SUBJECT: Install Scottish immigrant memorial cairn, Brunswick Town and Fort Anderson State

Historic Site, Brunswick County, GS 22-2964

Memorial Design Specifications

Subj: Proposed Scottish Cairn at Brunswick Town/Fort Anderson

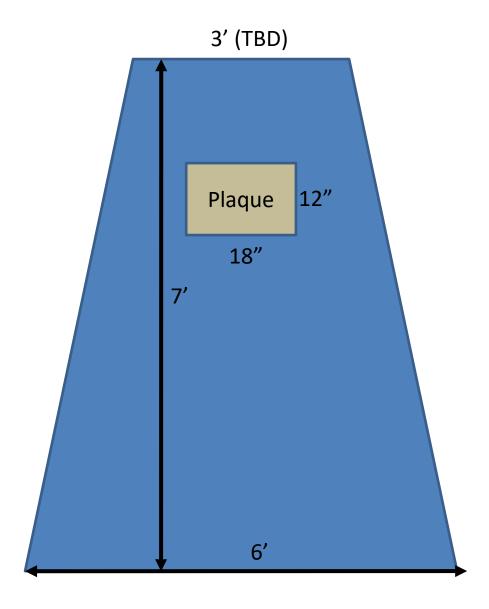
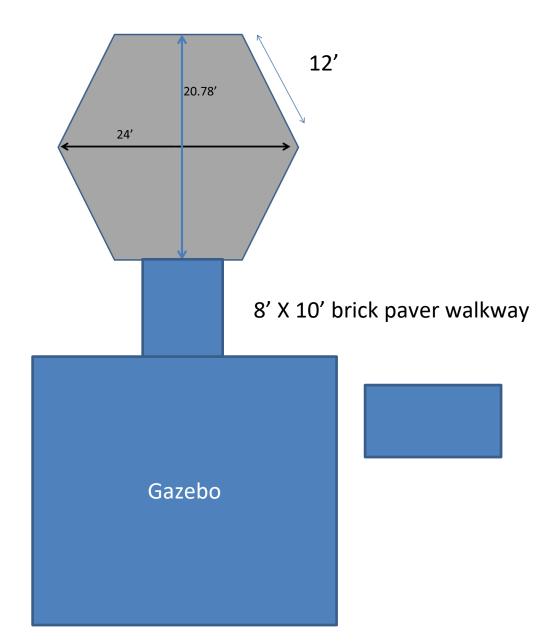
Request consideration of the proposed Scottish cairn at Brunswick Town be approved as developed in the proposal with the following changes included:

- 1. Removal of the flagpole
- 2. Proportionally reduce the height of the cairn to 6' vice 7'
- 3. Reduce the footprint of the walkway around the cairn to:

Suggested Walkway and Cairn Base
